Product Change Notification / MAAN-13RNNO081

eSign #E000190819 Final Notice: Released of updated Libero SoC v2022.3 and PF_CCC v2.2.220 for selected products in the PolarFire FPGA device family, including MPFxxx and RTPF device families.

Subject: PolarFire® FPGA, PolarFire SoC, and RT PolarFire FPGA PF_CCC Core Version Update to v2.2.214 Uses Incorrect LOCK_CNT Parameter Value

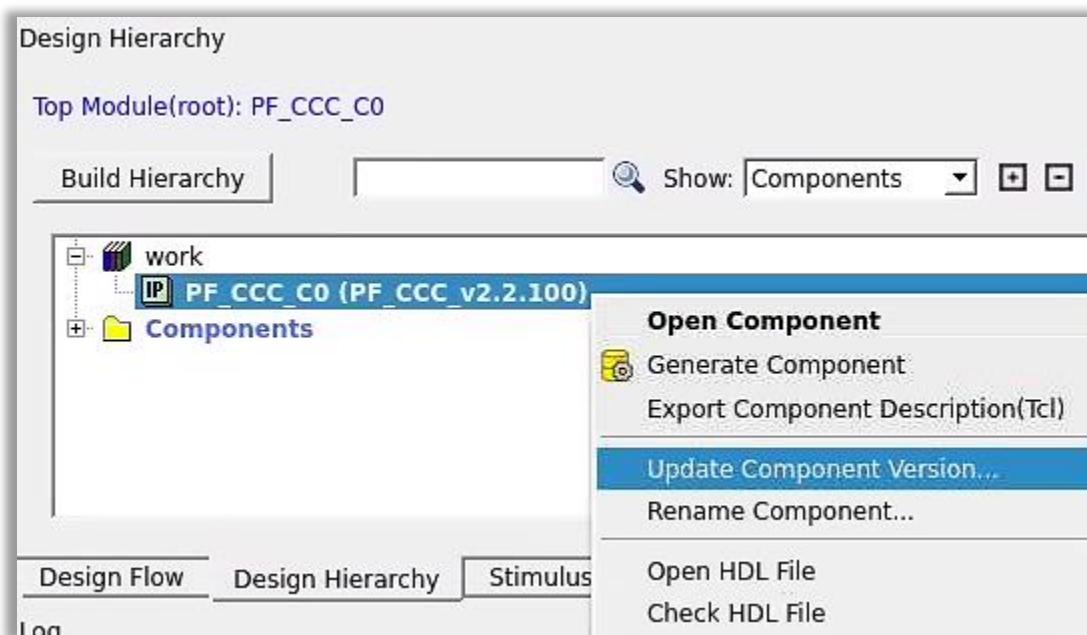
However, existing designs that were updated to Libero SoC version v2022.2, where an existing PF_CCC component instance was updated to v2.2.214, resulted in the PF_CCC core being re-generated with a LOCK_CNT parameter set to 0x0. This incorrect parameter setting reduces the number of extra PFD cycles to wait before asserting the PLL LOCK output from 256 cycles down to $2^0 = 1$ cycle.

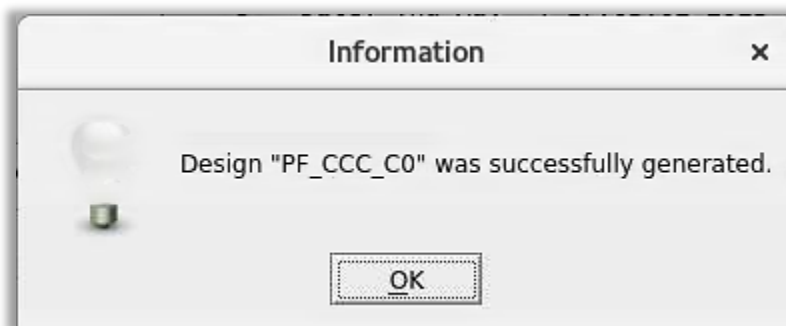
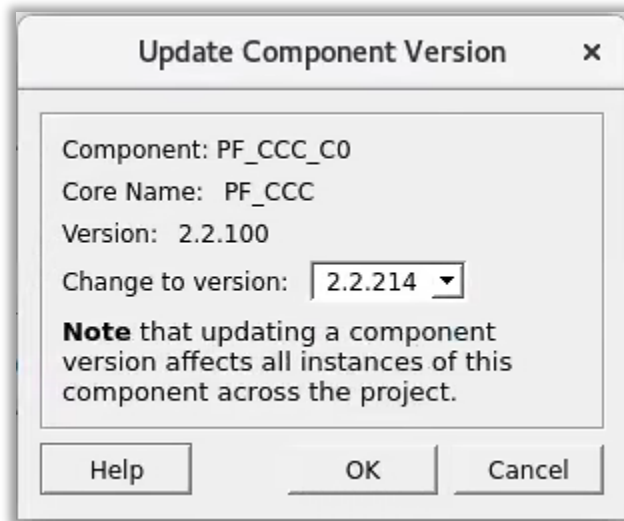
In the PF_CCC [Register Map](#), LOCKCOUNTSEL is 4-bit wide field at offset 9 of the PLL_CTRL2 register within the memory space of each PF_CCC. The LOCK_CNT parameter value of each PF_CCC instance in the user design maps to the PF_CCC LOCKCOUNTSEL field of the PLL_CTRL2 register. The figures below are excerpts from the PF_CCC register map, describing LOCKCOUNTSEL and its impact on the LOCK output.

Reg #	Reg Offset (Hex)	Register Name	Register Description	Field Name	Width	Field Offset	User	Silicon Default Value prior to Libero Customization	Field Description
6	18	PLL_CTRL2	PLL control register	LOCKCOUNTSEL	4	9	RW	0x8	Lock count select Selects the number of PFD edges after the last cycle slip before the lock signal goes high Count is defined as 2*LOCKCOUNTSEL (e.g. with LOCKCOUNTSEL=4'd8, LOCK will go high 256 PFD periods after the last cycle slip)

Reg #	Reg Offset (Hex)	Register Name	Register Description	Field Name	Width	Field Offset	User	Silicon Default Value prior to Libero Customization	Field Description
1	4	PLL_CTRL	PLL control register	LOCK	1	25	RO		Lock detect output LOCK goes high 2*LOCKCOUNTSEL PFD cycles after the last cycle slip LOCK goes low if two cycle slips are detected within 2*LOCKCOUNTSEL PFD cycles

In Libero SoC v2022.3 or later, and PF_CCC core v2.2.220 or later, the incorrect "Update Component Version" behavior is fixed. Upgrading an existing design to Libero SoC v2022.3, and updating any existing PF_CCC configured core component instance to v2.2.220, correctly re-generates the PF_CCC instance with the expected LOCK_CNT parameter value of 0x8.

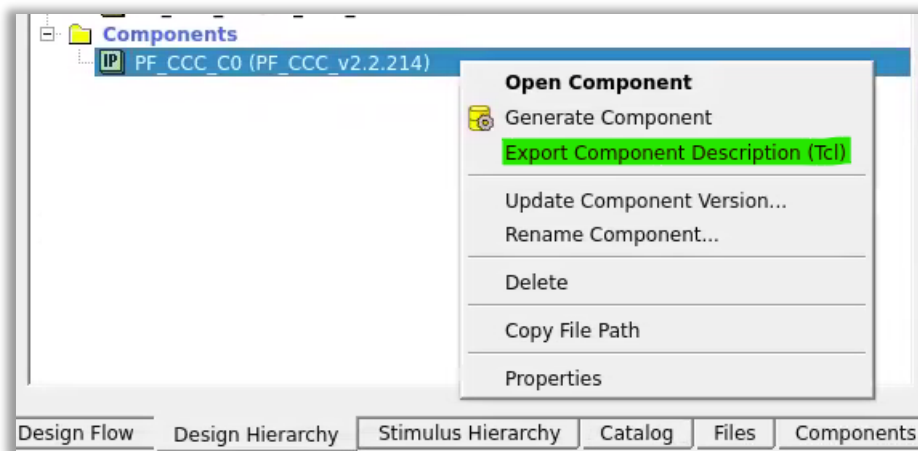
The “Update Component Version” action for a configured core component in Libero SoC is accessed by right-clicking the configured core component in the Design Hierarchy pane, as shown in the figures below. The “Update Component Version” action can also be accessed when the instantiated PF_CCC component core is instantiated on a SmartDesign canvas, via a right-click on the PF_CCC canvas instance. Running the “Update Component Version” action automatically regenerates the existing configured core, with the goal of using the updated core configurator while retaining the existing user configuration.

Use one of the following 3 methods to resolve the issue:

Method #1:

- Upgrade to Libero SoC v2022.3, or later, and upgrade all PF_CCC instances to v2.2.220, or later.
- Then re-run the design flow.
